# TFFC IF- ADA Evaluation

**IF-Athens TX, TFFC ADA Evaluation**

**Accessibility Evaluation**

**Inspection Date: 11/15/2022**

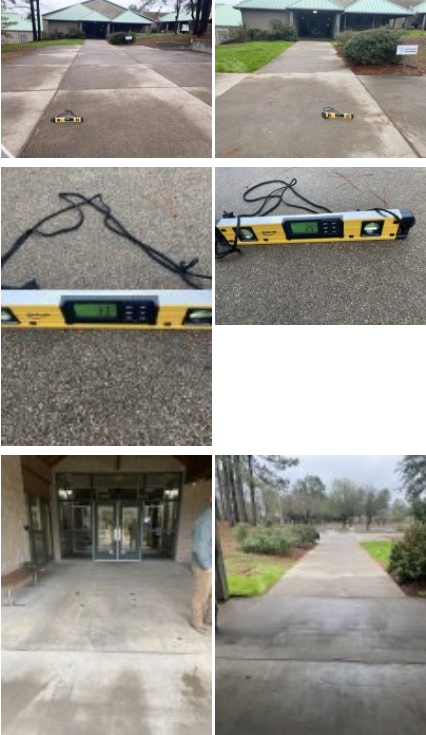
4	Exterior of Property (Public) - Parking Lots/Walkways : Path of Travel Parking Lot to Visitors Center Admission - Entrance Ramps (Non Curb Ramp)	The ramp run has not been provided with edge protection. The floor or ground surface of the ramp run or landing shall extend 12 inches minimum beyond the inside face of a handrail or a curb or barrier shall be provided that prevents the passage of a 4 inch diameter sphere, where any portion of the sphere is within 4 inches of the finish floor or ground surface.	Edge protection looks higher than 4" Both sides of ramp would need rails with correct edge protection. 2 ways to satisfy compliance 1- install bottom bar at 4" or less 2- add ground surface to extend 12" minimum from handrails	<a href="https://www.access-board.gov/ada/#ada-405_9_1">https://www.access-board.gov/ada/#ada-405_9_1</a> <a href="https://www.access-board.gov/ada/#ada-405_9_2">https://www.access-board.gov/ada/#ada-405_9_2</a>	2012 TAS Section: 405.9.1, 405.9.2  2010 ADAS Section: 405.9.1, 405.9.2  2015 ABAAS Section: 405.9.1, 405.9.2

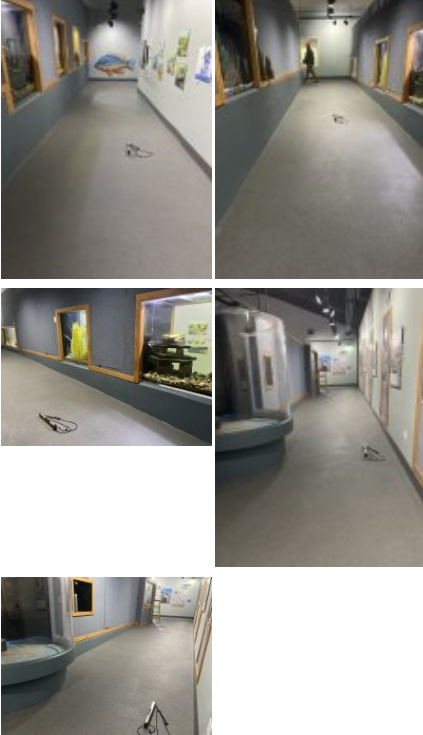
26	Structures on Property (Public) - Visitors Center : Restrooms/Water Fountains (Admission) - Restroom (Women's) Admission	The force required to operate the element exceeds the maximum allowable force. The force required to activate operable parts is 5 pounds maximum.	6 pounds of force	<a href="https://www.access-board.gov/ada/#ada-309_4">https://www.access-board.gov/ada/#ada-309_4</a>	2012 TAS Section: 309.4 2010 ADAS Section: 309.4 2015 ABAAS Section: 309.4

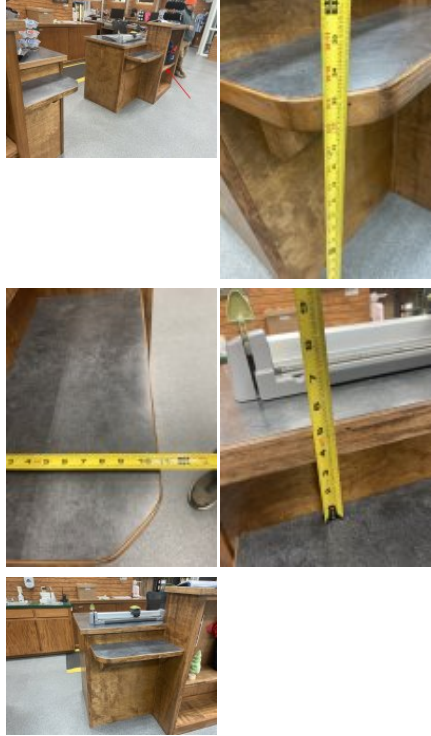
37	Structures on Property (Public) - Visitors Center : Outdoor Exhibits - Stream Pond Ramp	The handrail exceeds maximum height requirements. Handrails are measured to the top of the gripping surface and must be between 34 inches and 38 inches above the ramp surface. Handrails must extend horizontally 12 inches beyond the top and bottom of the ramp.	Handrail height is over 41" (L) side of ramp	<a href="https://www.access-board.gov/ada/#ada-505_4">https://www.access-board.gov/ada/#ada-505_4</a>	2012 TAS Section: 505.4  2010 ADAS Section: 505.4  2015 ABAAS Section: 505.4

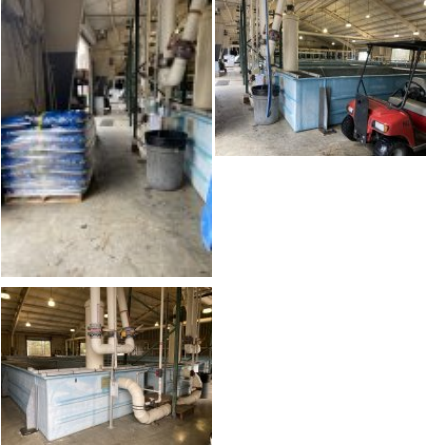
Finding Number	Area Description	Finding	As Built	Recommendation	Citation	Photos	Figure
56	Structures on Property (Public) - Visitors Center : Restrooms/Water Fountains (Overlook) - Restroom (Men's) Overlook	The coat hook is installed greater than 48 inches above the finished floor. Where a forward reach is unobstructed, the high forward reach shall be 48 inches maximum above the finished floor.	Coat hook height is over 59"	<a href="https://www.access-board.gov/ada/#ada-308_2_1">https://www.access-board.gov/ada/#ada-308_2_1</a>	2012 TAS Section: 308.2.1  2010 ADAS Section: 308.2.1  2015 ABAAS Section: 308.2.1		 Considered Unobstructed
57	Structures on Property (Public) - Visitors Center : Restrooms/Water Fountains (Overlook) - Restroom (Men's) Overlook	The floor drain is set too low in the floor which causes a slope over 2 percent. Changes in level are not permitted in clear floor or ground spaces or surfaces of a turning spaces and shall not slope greater than 1:48.	Floor drain slope is 3.1%	<a href="https://www.access-board.gov/ada/#ada-303_3">https://www.access-board.gov/ada/#ada-303_3</a> <a href="https://www.access-board.gov/ada/#ada-304_2">https://www.access-board.gov/ada/#ada-304_2</a>	2012 TAS Section: 303.3, 304.2, 304.2 Exception  2010 ADAS Section: 303.3, 304.2, 304.2 Exception  2015 ABAAS Section: 303.3, 304.2, 304.2 EXCEPTION, 305.2 EXCEPTION

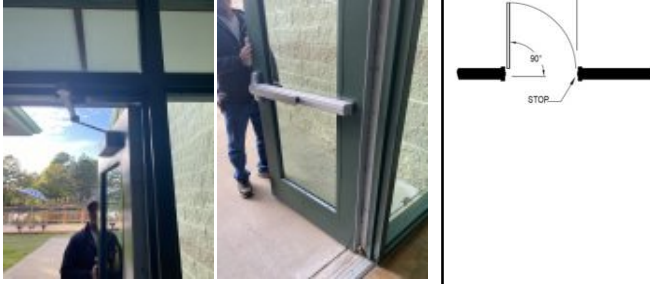
60	Structures on Property (Public) - Visitors Center : Restrooms/Water Fountains (Overlook) - Restroom (Men's) Overlook	The room identification sign is noncompliant. Wall signs identifying permanent rooms and spaces of a building shall be in a horizontal format and the characters raised 1/32 inch minimum and shall be sans serif uppercase characters a minimum of 5/8 inch and a maximum of 2 inches high. Characters and their background shall have a non-glare finish. Characters shall contrast with their background with either light characters on a dark background or dark characters on a light background. Signs with raised characters or Braille shall be located 48 inches minimum above the finish floor or ground surface, measured from the baseline of the lowest tactile character and 60 inches maximum above the finish floor or ground surface, measured from the baseline of the highest tactile character.	Temporary paper sign needs to be replaced with correct sign type and mounted in correct location.	Wall sign designation <a href="https://www.access-board.gov/ada/#ada-216_2">https://www.access-board.gov/ada/#ada-216_2</a> Wall signs general <a href="https://www.access-board.gov/ada/#ada-703_1">https://www.access-board.gov/ada/#ada-703_1</a>	2012 TAS Section: 216.2, 703.1  2010 ADAS Section: 216.2, 703.1  2015 ABAAS Section: F216.2, 703.1

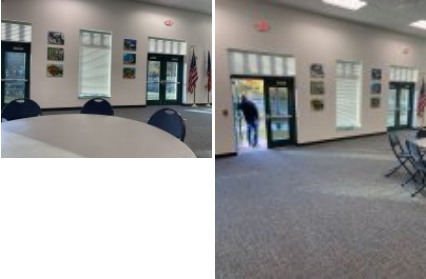
72	Structures on Property (Public) - Conservatory Center: Restrooms/Water Fountains (Conservation Center) - Restroom (Men's)	An accessible urinal is not provided. Where more than one urinal is provided, at least one shall be accessible.	If there is more than one urinal in a bathroom, at least one must follow accessibility guidelines. Pending verification	Min number required <a href="https://www.access-board.gov/ada/#ada-213_3_3">https://www.access-board.gov/ada/#ada-213_3_3</a> Review urinal elements <a href="https://www.access-board.gov/ada/#ada-605">https://www.access-board.gov/ada/#ada-605</a>	2010 ADAS Section: 213.3.3		
73	Structures on Property (Public) - Conservatory Center: Restrooms/Water Fountains (Conservation Center) - Restroom (Men's)	The threshold has a vertical change greater than 1/4 inch. The threshold at a doorway shall be no higher than 1/2 inch. Changes in level between 1/4 inch and 1/2 inch must be beveled at 1:2 or less. The maximum vertical rise shall be 1/4 inch.	N/A	<a href="https://www.access-board.gov/ada/#ada-404_2_5">https://www.access-board.gov/ada/#ada-404_2_5</a>	2012 TAS Section: 404.2.5  2010 ADAS Section: 404.2.5  2015 ABAAS Section: 404.2.5

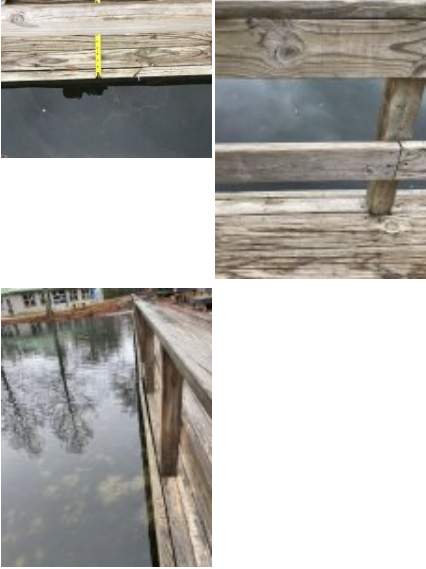
Finding Number	Area Description	Finding	As Built	Recommendation	Citation	Photos	Figure
114	Outdoor Features (Public) : Fishing Piers Near Visitors Center (3 total) - Conservation Center Fishing Pier & Walkways	The walkway contains abrupt vertical edges and/or variations over 1/4 inch. 1/4 inch is the maximum vertical rise. Changes in level between 1/4 inch and 1/2 inch must be beveled at 1:2 or less. Changes in level greater than 1/2 inch must be by way of a ramp.	Exterior pathway used to gain access to CC fishing pier has transition over 1/4" in 2 locations. Same locations also have gap greater than 1/2" See additional photos for locations.	<a href="https://www.access-board.gov/ada/#ada-303_2">https://www.access-board.gov/ada/#ada-303_2</a> <a href="https://www.access-board.gov/ada/#ada-303_3">https://www.access-board.gov/ada/#ada-303_3</a>	2012 TAS Section: 303.3, 303.2  2010 ADAS Section: 303.3, 303.2  2015 ABAAS Section: 303.2, 303.3

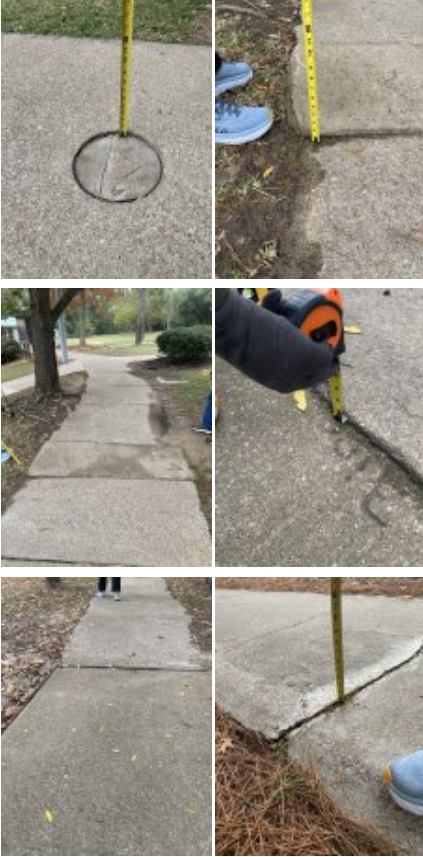
123	Outdoor Features (Public) : Fishing Piers Near Visitors Center (3 total) - Anglers Pavilion Fishing Pier & Walkways	The route contains openings greater than 1/2 inch. Openings in floor or ground surfaces shall not allow passage of a sphere more than 1/2 inch diameter. Elongated openings shall be placed so that the long dimension is perpendicular to the dominant direction of travel.	Exterior pathways leading to Angler Pavilion fishing pier have multiple locations where gap exceed 1/2"	<a href="https://www.access-board.gov/ada/#ada-302_3">https://www.access-board.gov/ada/#ada-302_3</a>	2012 TAS Section: 302.3 2010 ADAS Section: 302.3 2015 ABAAS Section: 302.3

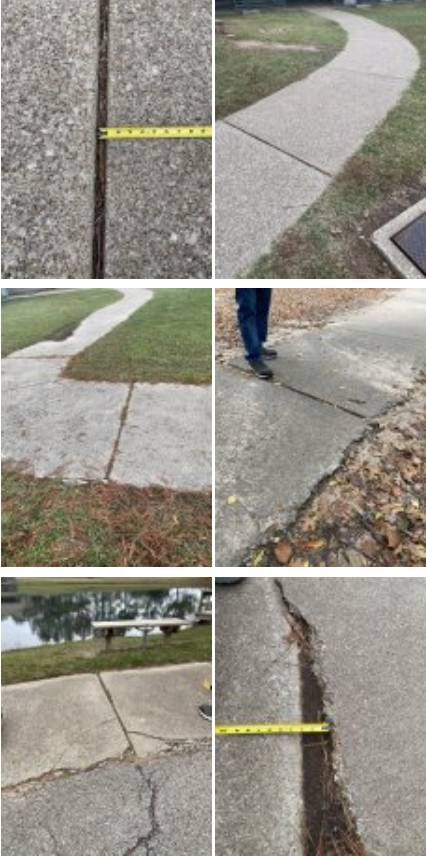
Finding Number	Area Description	Finding	As Built	Recommendation	Citation	Photos	Figure
124	Outdoor Features (Public) : Fishing Piers Near Visitors Center (3 total) - Path Of Travel Around Piers	The accessible route on the site has running slopes greater than 5 percent and has not been constructed as a ramp (i.e. handrails, edge protection, etc.). When the slope in the direction of travel of any walk exceeds 1 unit vertical in 20 units horizontal (5-percent slope), it must be constructed as a ramp. Surface cross slopes must not exceed one unit vertical in 48 units horizontal (2-percent slope).	There are several locations where exterior pathway exceeds running slope of 5%. This section of pathway accesses Mr. Bills fishing pier, maneuvers around pier heading towards outdoor picnic area. See additional photos for location of running slope non compliance on accessible pathway to feature.	<a href="https://www.access-board.gov/ada/#ada-403_3">https://www.access-board.gov/ada/#ada-403_3</a>	2012 TAS Section: 403.3 2010 ADAS Section: 403.3 2015 ABAAS Section: 403.3

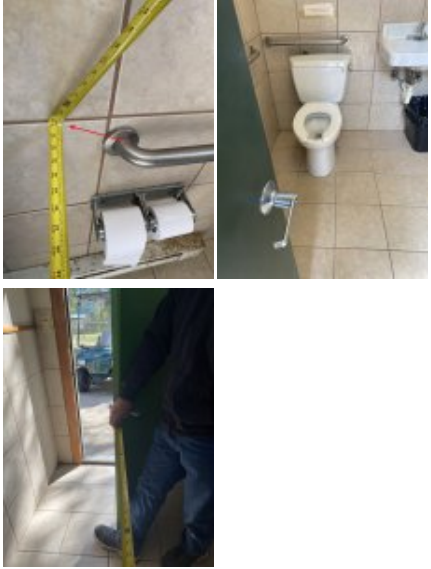
154	Outdoor Features (Public) : Fly Fishing Area - Restroom (Men's)	The threshold is greater than 1/2 inch high. The threshold at a doorway shall be no higher than 1/2 inch. Changes in level between 1/4 inch and 1/2 inch must be beveled at 1:2 or less. 1/4 inch is the maximum vertical rise.	Entry into restroom may comply with beveled requirements, verify. Exiting restroom is not compliant, threshold exceeds 1/2"		<a href="https://www.access-board.gov/ada/#ada-404_2_5">https://www.access-board.gov/ada/#ada-404_2_5</a>  2012 TAS Section: 404.2.5  2010 ADAS Section: 404.2.5  2015 ABAAS Section: 404.2.5

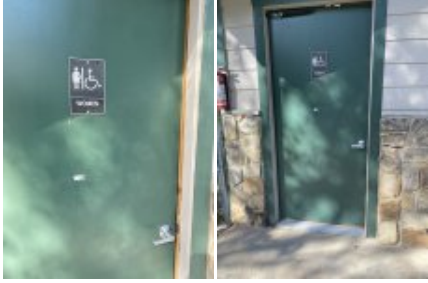
162	Outdoor Features (Public) : Fly Fishing Area - Restroom (Women's)	The lavatory's clear floor space is obstructed by the paper towel dispenser. The wall mounted soap dispenser projects (XX) from the wall and encroaches into the required 30 inches by 48 inches clear floor space. The maximum projection that a dispenser may project at this location is (XX) inches.	Paper towel dispenser location, soap dispenser, and trash can prevent access to lavatory.		<a href="https://www.access-board.gov/ada/#ada-606_2">https://www.access-board.gov/ada/#ada-606_2</a> 2012 TAS Section: 606.2 2010 ADAS Section: 606.2 2015 ABAAS Section: 606.2		
163	Outdoor Features (Public) : Fly Fishing Area - Restroom (Women's)	The lavatory is too close to the side wall. There must be a minimum of 15 inches from the centerline of the lavatory to the nearest side wall or side partition to allow for an unobstructed 30 inches by 48 inches clear floor space.	Midline of lavatory is 12" from side wall.		<a href="https://www.access-board.gov/ada/#ada-606_2">https://www.access-board.gov/ada/#ada-606_2</a> 2012 TAS Section: 606.2 2010 ADAS Section: 606.2 2015 ABAAS Section: 606.2

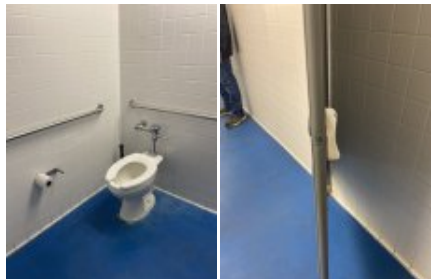
175	Outdoor Features (Public) : Picnic Spaces Near Visitors Center - Overlook Area	There is no outdoor recreation access route that connects accessible elements, spaces, and facilities within the picnic unit. At least one outdoor recreation access route shall connect accessible elements, spaces, and facilities provided within picnic units with mobility features.	Ground/surface material not compliant around picnic tables. Exterior pathway leading to tables non compliant.	N/A - Refer to Finding	2015 ABAAS Section: F245.4.1

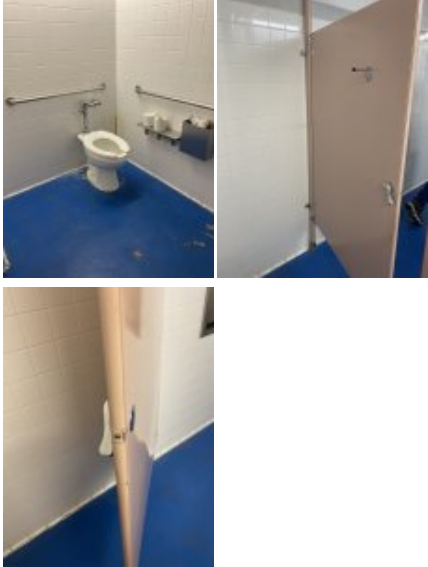
177	Structures on Property (STAFF) - Visitor Center Top Floor: Entrance into Staff Work Area - Entrance Doors	The floor mat at the door is not secured in place. If carpet or carpet tile is used on a ground or floor surface, then it shall be securely attached; have a firm cushion, pad or backing or no cushion or pad; and have a level loop, textured loop, level-cut pile or level-cut/uncut pile texture. The maximum pile height shall be 1/2 inch. Exposed edges of carpet shall be fastened to floor surfaces and have trim along the entire length of the exposed edge. Recessed doormats shall be adequately anchored to prevent interference with wheelchair traffic.	Floor Mat is not in good working condition or secured to floor. Carpet fraying and deteriorating to right of floor mat, not located on main path of travel.	<a href="https://www.access-board.gov/ada/#ada-302_2">https://www.access-board.gov/ada/#ada-302_2</a>	2012 TAS Section: 302.2  2010 ADAS Section: 302.2  2015 ABAAS Section: 302.2

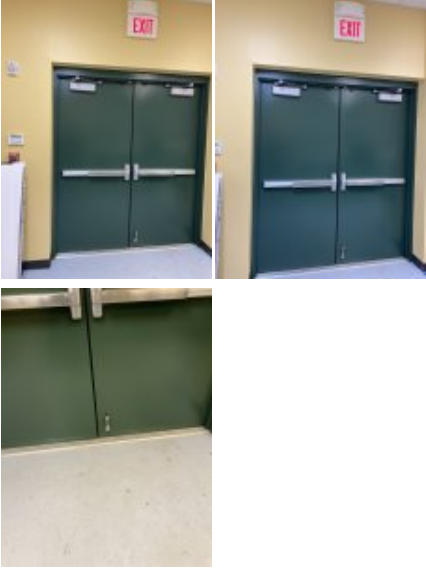
Finding Number	Area Description	Finding	As Built	Recommendation	Citation	Photos	Figure
188	Structures on Property (STAFF) - Visitor Center Bottom Floor: Restrooms/Water Fountains - Water Fountain	The drinking fountain has multiple violations. Drinking fountains must be on an accessible route that provides a 30 inch by 48 inch clear floor space centered on the low unit, allowing a forward approach. Spout outlets shall be 36 inches maximum above the finish floor or ground. Spout outlets of drinking fountains for standing persons shall be 38 inches minimum and 43 inches maximum above the finish floor or ground. The spout shall be located 15 inches minimum from the vertical support and 5 inches maximum from the front edge of the unit, including bumpers. The spout shall provide a flow of water 4 inches high minimum and shall be located 5 inches maximum from the front of the unit. The angle of the water stream shall be measured horizontally relative to the front face of the unit. Where spouts are located less than 3 inches of the front of the unit, the angle of the water stream shall be 30 degrees maximum. Where spouts are located between 3 inches and 5 inches maximum from the front of the unit, the angle of the water stream shall be 15 degrees maximum. Operable parts shall comply with applicable standards.	Standing water fountain is not provided. Its required that if one is provided then the other option is as well. Water refill station cannot take the place of either water fountain unless only water refill station is provided and no water fountains. The Building Code may only require one drinking fountain be provided, but the Accessibility Standards require at least two. One at a lower height and the other at standing height.	Review drinking fountain requirements Clear floor space <a href="https://www.access-board.gov/ada/#ada-403_5_1">https://www.access-board.gov/ada/#ada-403_5_1</a> Drinking fountain requirements, general <a href="https://www.access-board.gov/ada/#ada-602_1">https://www.access-board.gov/ada/#ada-602_1</a>	2012 TAS Section: 403.5.1, 602.1  2010 ADAS Section: 403.5.1, 602.1  2015 ABAAS Section: 403.5.1, 602.1
